Notice of Amendment to Topaz Irrigation POD Transfer Application

MEMORANDUM

DATE: July 29, 2016
TO: Stony Yakovac
Boxcar Farm
6500 Hwy 30 E.
Lava Hot Springs, Idaho 83246
Delivered via email to:
svakovac@gmail.com
FROM: Christian R. Petrich, Ph.D., P.E., P.G.
RE: Conveyance loss estimates for Transfer 80731

Figure 1. Current and proposed PODs under water right 29-180.

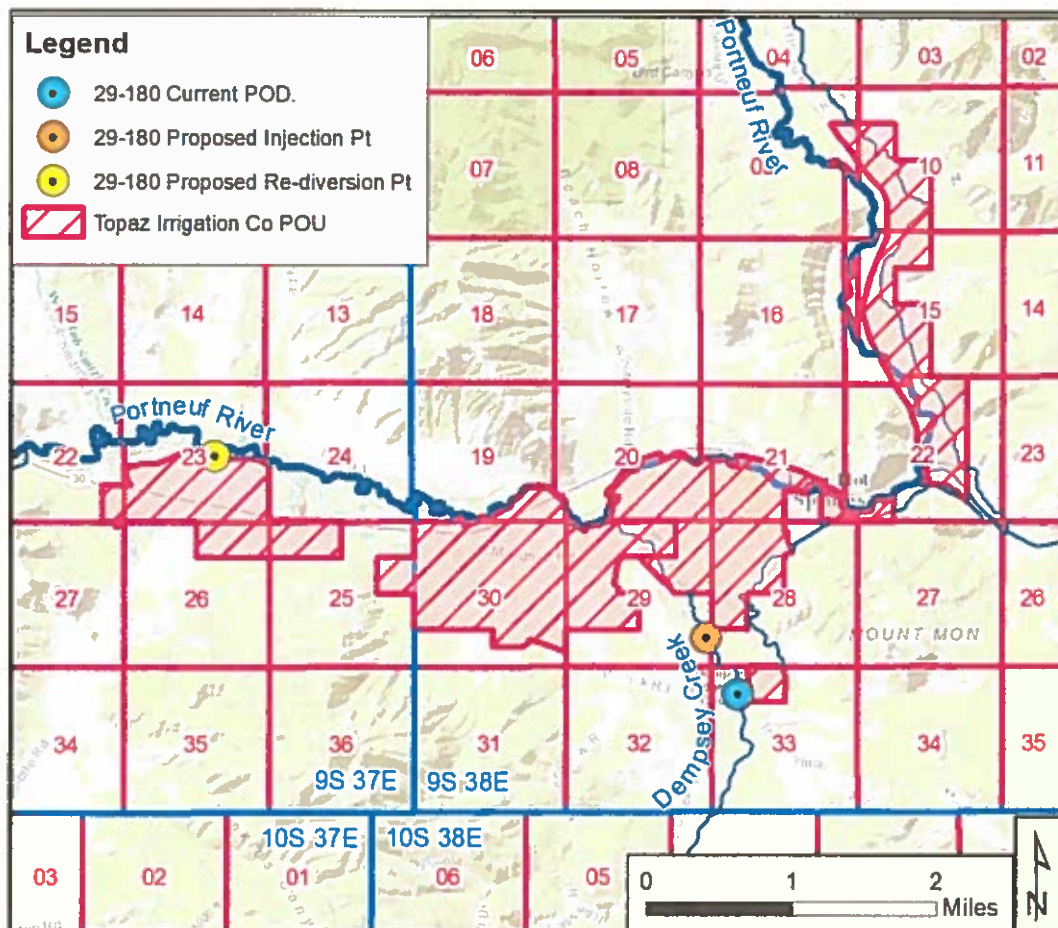
Water Right 29-180 authorizes the diversion of up to 13.44 cfs between April 15 and September 15 from Dempsey Creek at a single point of diversion (POD) in the SENWNW

of Section 33 in Township 9S, Range 38E in Bannock County (Figure 1). Water right 29-180 authorizes the use of this water for the irrigation of 672 acres under an April 1, 1883 priority date. Transfer Application 80731 proposes adding a new POD in the SWNE of Section 23, Government Lot 2, Township 9S, Range 37E (Figure 1). The full 13.44 cfs will be diverted (when available) at the current POD. A portion of this amount – 2.109 cfs – will be re-injected into Dempsey Creek approximately 0.7 miles downstream of the current POD. This amount, less any losses, will be re-diverted from the proposed new POD in Section 23 of Township 9S, Range 37E.
